July 10, 2020

Subject: U.S. Department of Energy Responses to U.S. Nuclear Regulatory Commission Staff Comments on the *2019 Annual Site Inspection and Monitoring Report for Uranium Mill Tailings Radiation Control Act Title II Disposal Sites*

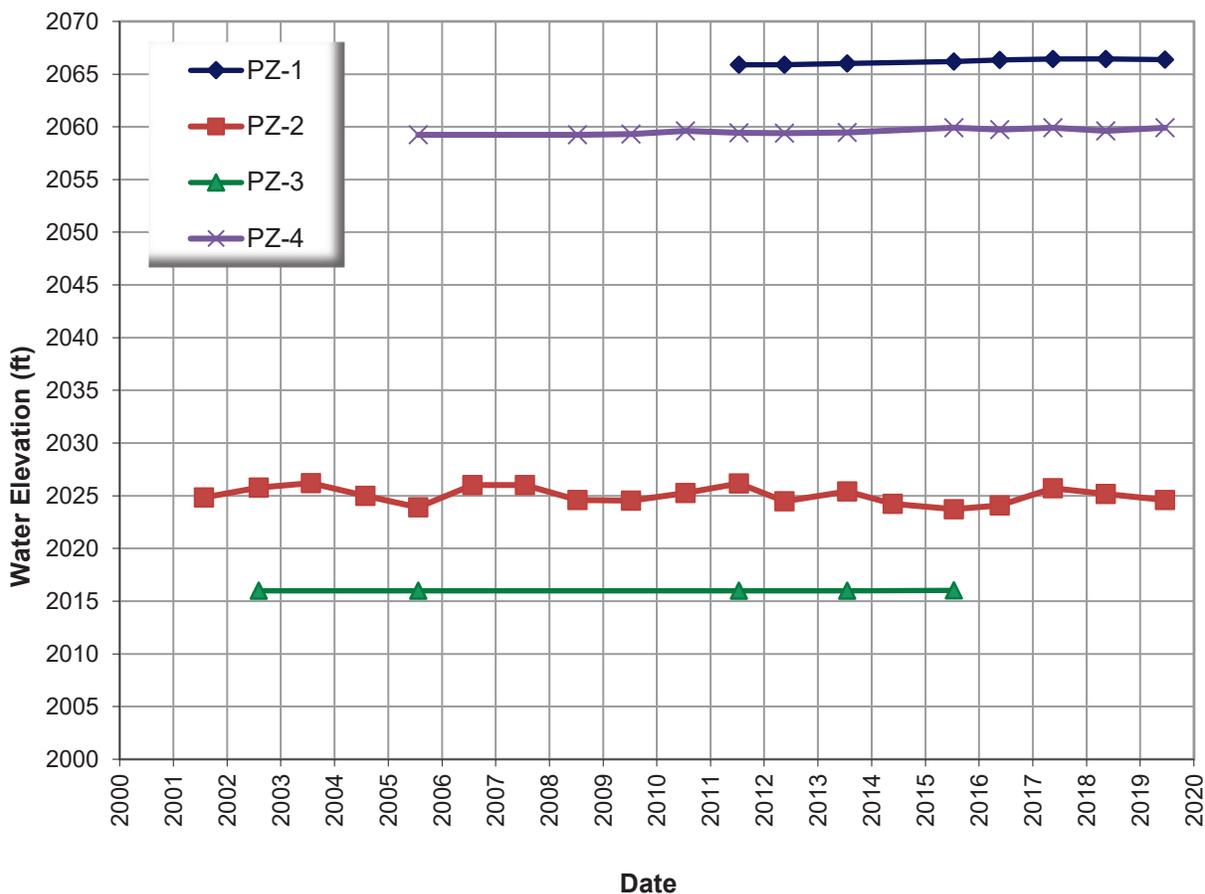
NRC Comment 2

Additionally, for the Sherwood site, the inspection report discusses the containment dam evaluations using the results of the four piezometers at the site that are used to evaluate moisture conditions in the containment dam. Understanding the moisture condition trends in the containment dam is an important aspect of its performance. The inspection report only includes the current piezometer results and it would be useful if the DOE included the results for the piezometers since their installation in 2000 in the 2020 report (perhaps as a graph similar to the water elevation data presented in Figures 5-5 and 5-6). Presentation of such a graph would enhance the NRC staff's understanding of the moisture conditions in the containment dam.

DOE Comment 2 Response

In future annual inspection and monitoring reports, DOE will provide complete piezometer water elevation results since their installation in 2000. The chart requested is provided below. It should be noted that gaps in water elevation data indicate dry sample events.
